**ONSITE SEWAGE DISPOSAL SYSTEM**

PROPERTY ADDRESS: 15241 SWEETBAY STREET, WOODBINE, MD 21797

LOCATION DRAWING / WALL CHECK  
#15241 SWEETBAY STREET  
LOT 38  
BELLE HAVEN ESTATES  
PLAT No. 19953

## SITE PLAN FOR BAT INSTALLATION

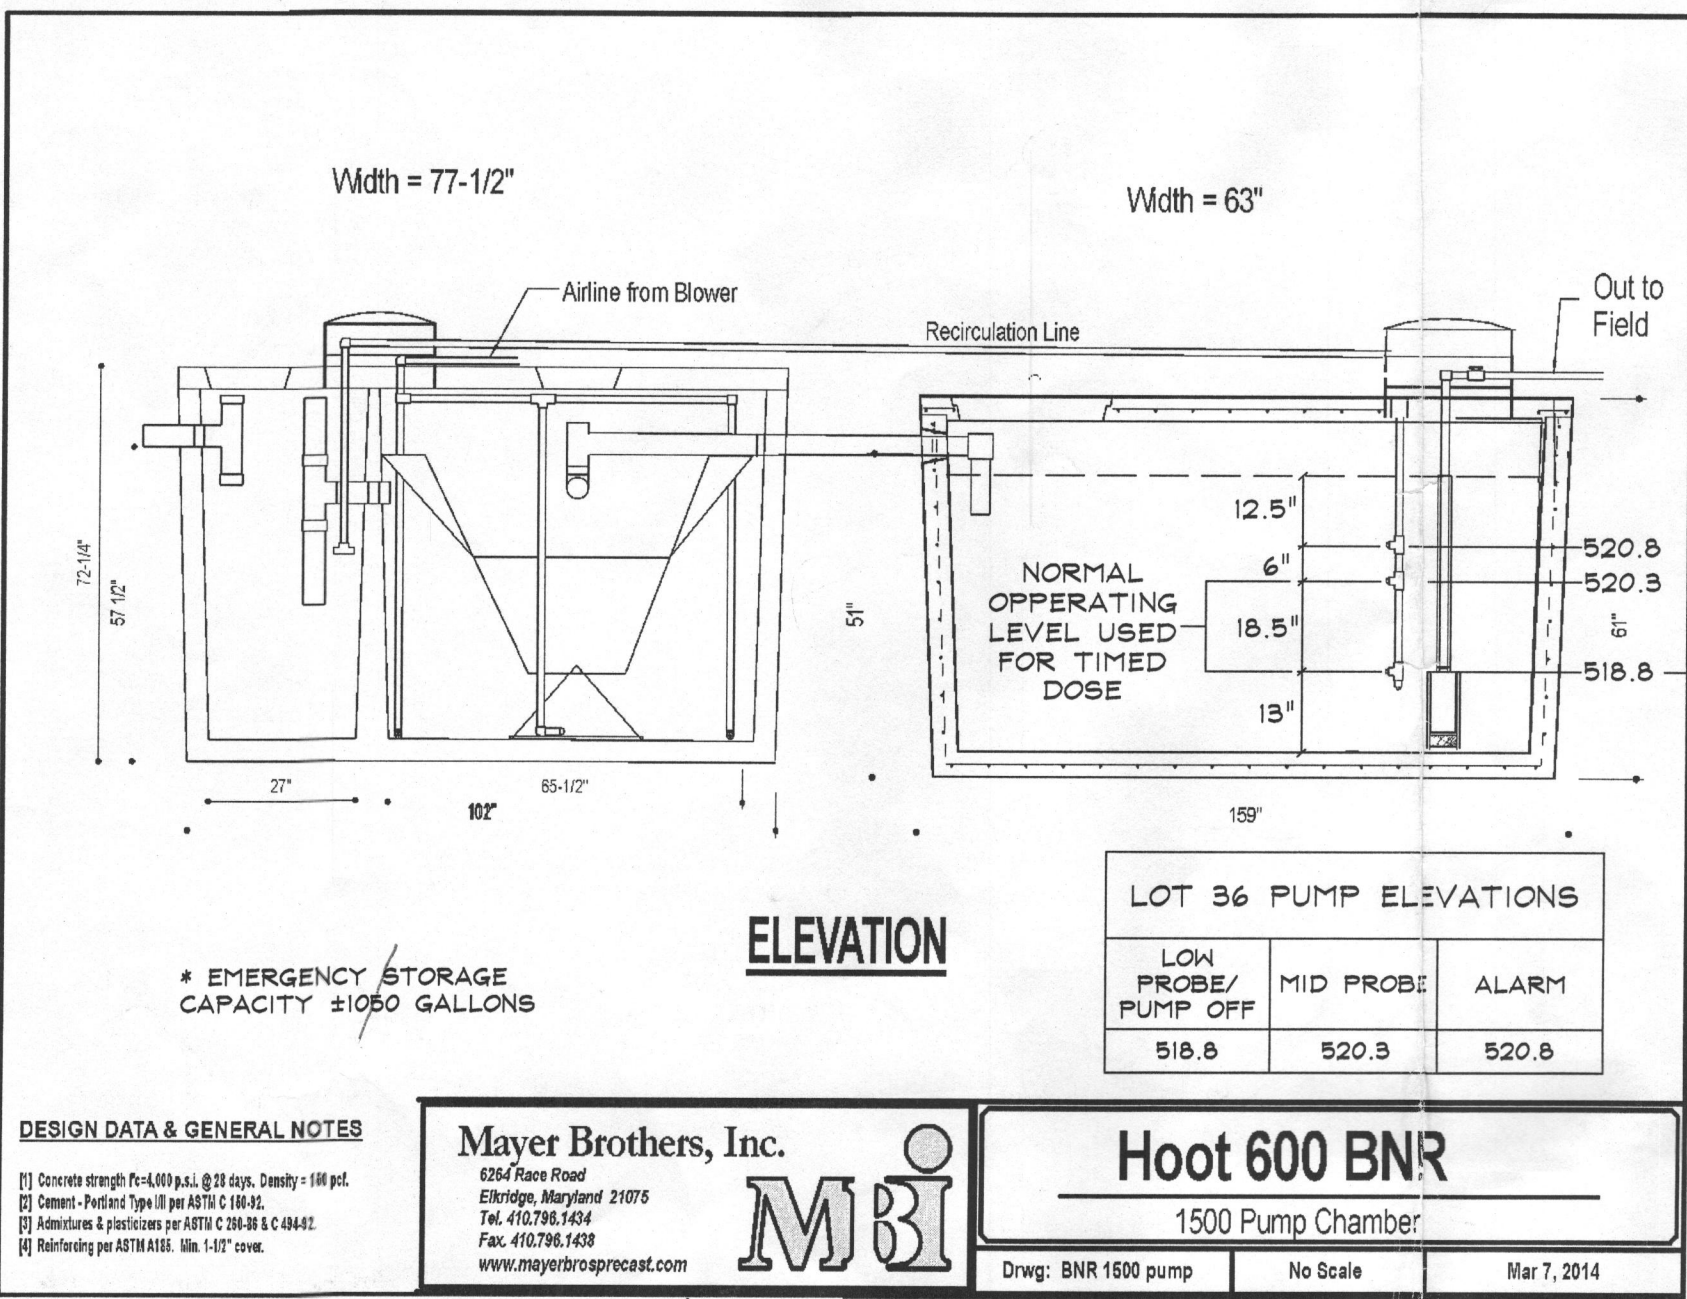
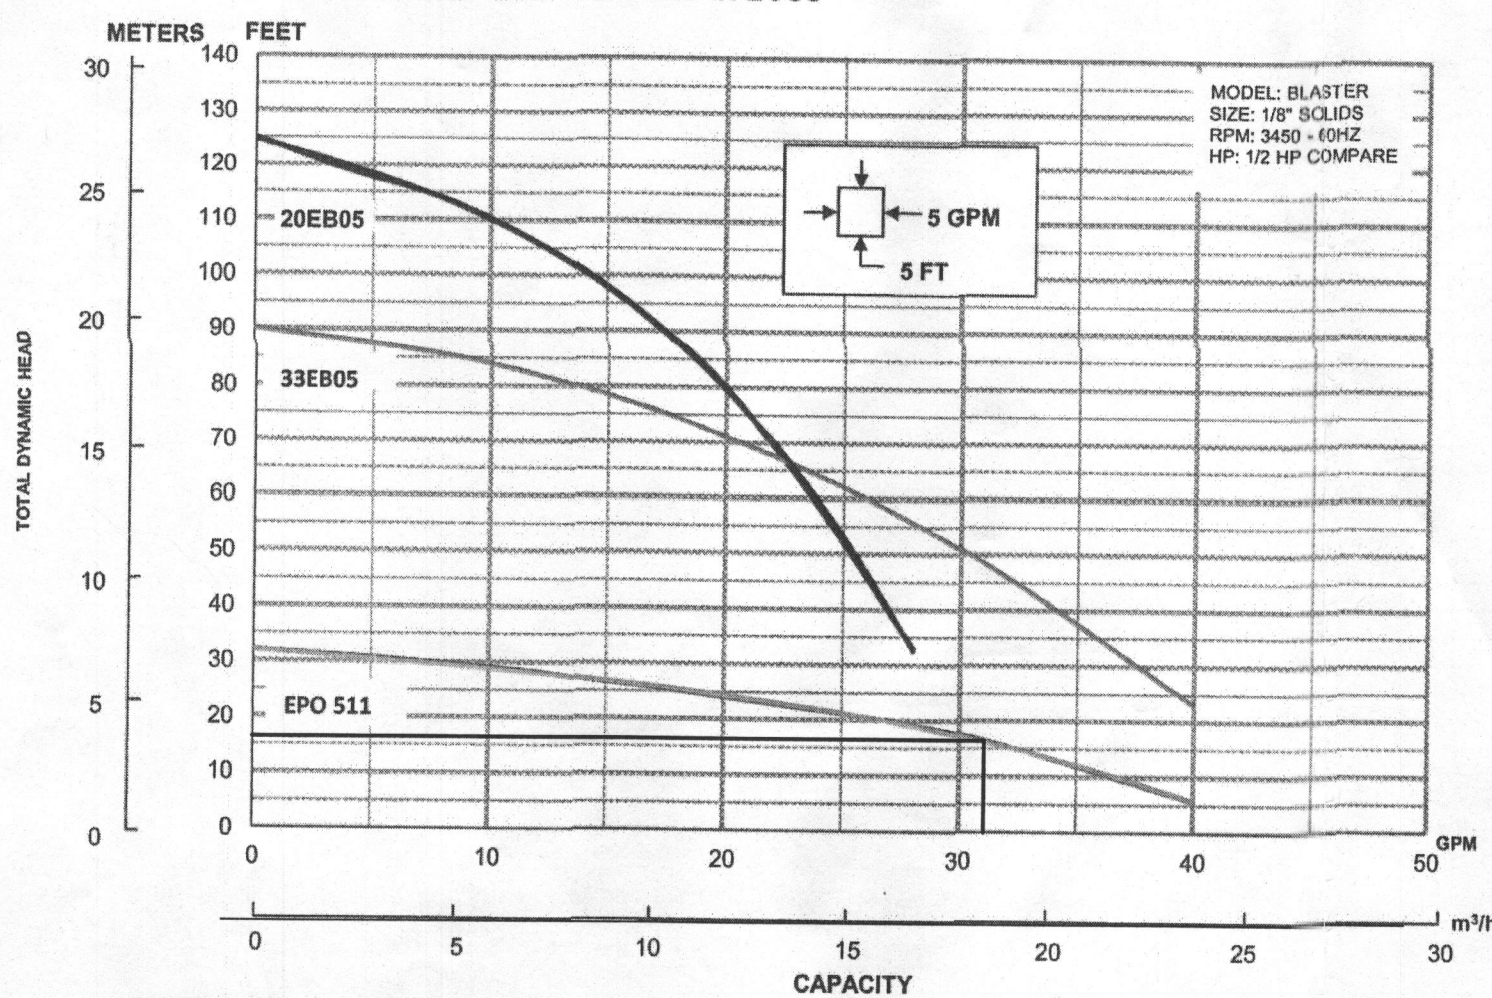
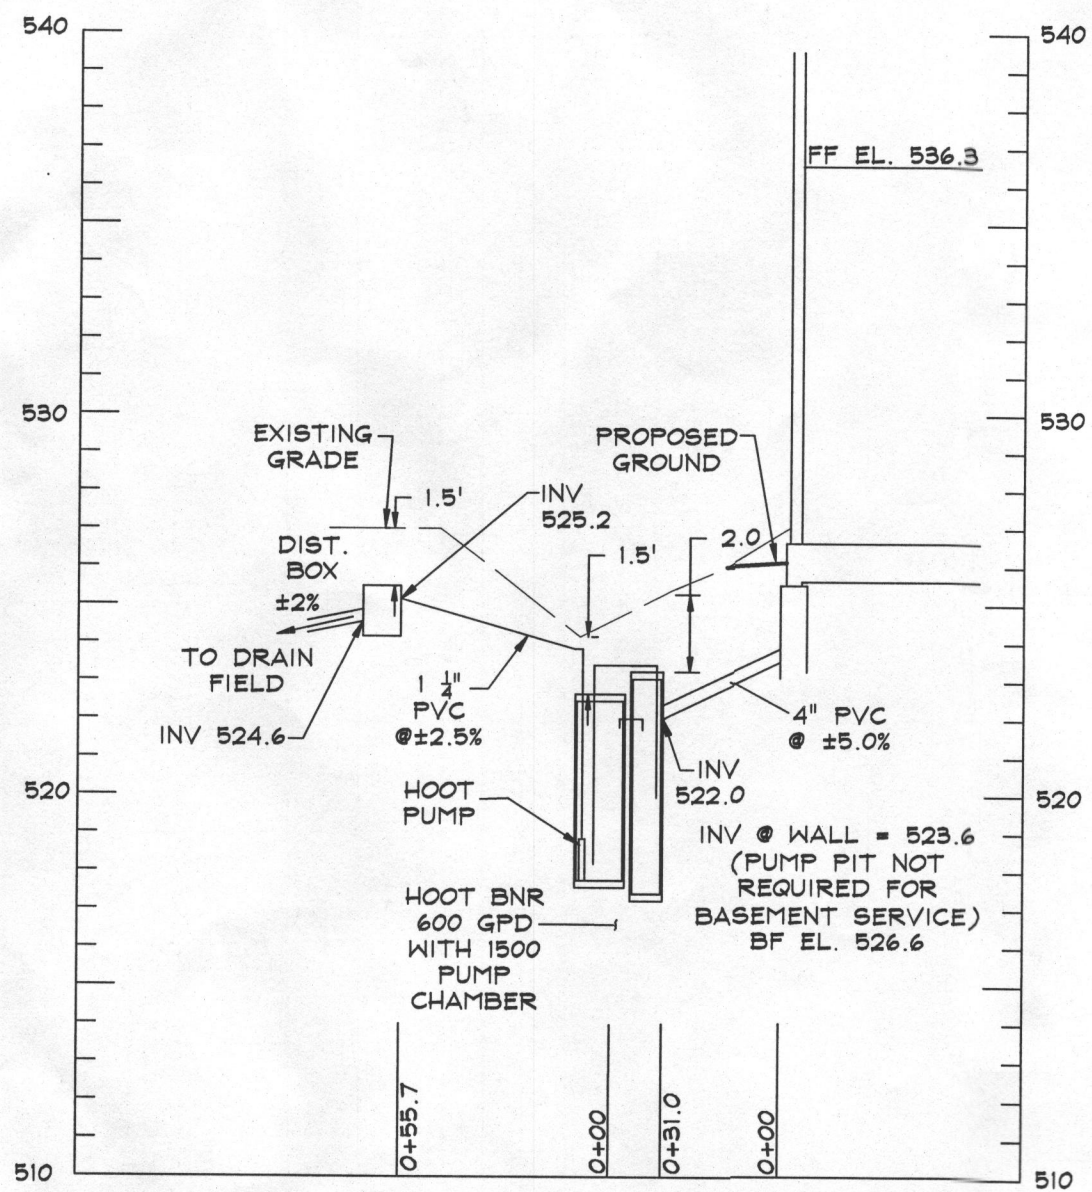
Your BAT plan must be revised to reflect a Hoot system which can support a 6 bedroom house. The current BAT plan shows a Hoot system with a 600 GPD. However, the proposed system reflects a 900 GPD. The 600 BNR only has enough emergency storage for a 5 bedroom design (it has ~790 gallons of storage, which is good for a 750 g design flow). A 900 g design for a 6 bedroom home must show either a hoot with a bigger emergency storage capacity or a separate pump chamber to get to at least 900 g emergency storage. Please show and note the emergency storage capacity on the plan. Please revise and resubmit. Our office will review the plan as soon as we receive the revision.
